2018/3672/P - Objection

I am writing in response to the Planning application 2018/3672/P. As the official consultation has ended, it is not possible to upload this objection via website. I can see that the evidence is still being added. Could you kindly register this **Objection** and make it visible on the website.

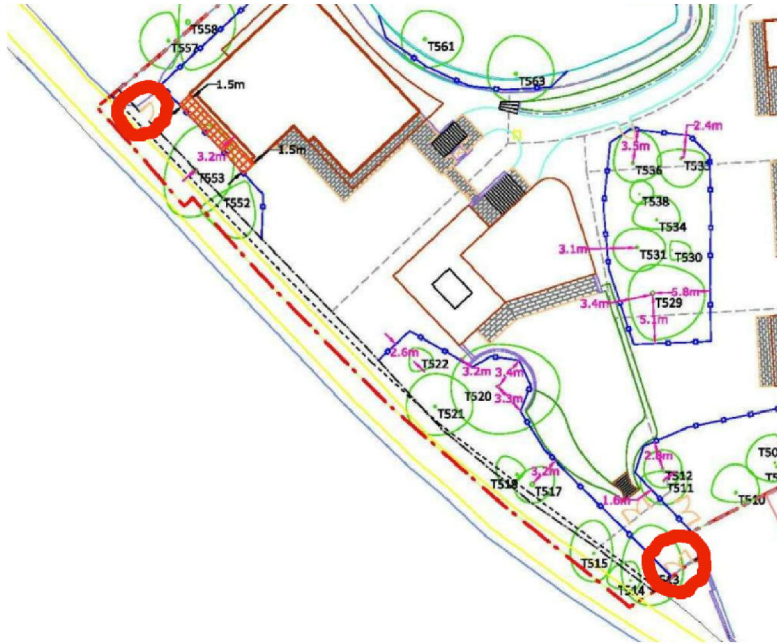
2. Can the Applicant please clarify if all the pedestrian and vehicular paths on the estate are included into the calculation of the proposed impervious area (i.e. artificial area) in the SuDS PROFORMA. In particular, **the purpose of the gates** shown on the picture below is not clear (screenshot from p7 of the Assessment of Drainage Proposals, January 2021), as the pathways (pedestrian or vehicular) leading from these gates to the new developments are not shown. The historic gates are visible on the wooden fencing from Millfield lane, and it would be useful to understand if/how they are going to be used by the new development.

In addition to the intended use of these gates, could the Applicant please clarify their design. From the experience with the Water House gate upgrade, as the **visual look and use of these gates affects users of the Hampstead Heath**, this should be included in this or separate public consultation facilitated by Camden Council.
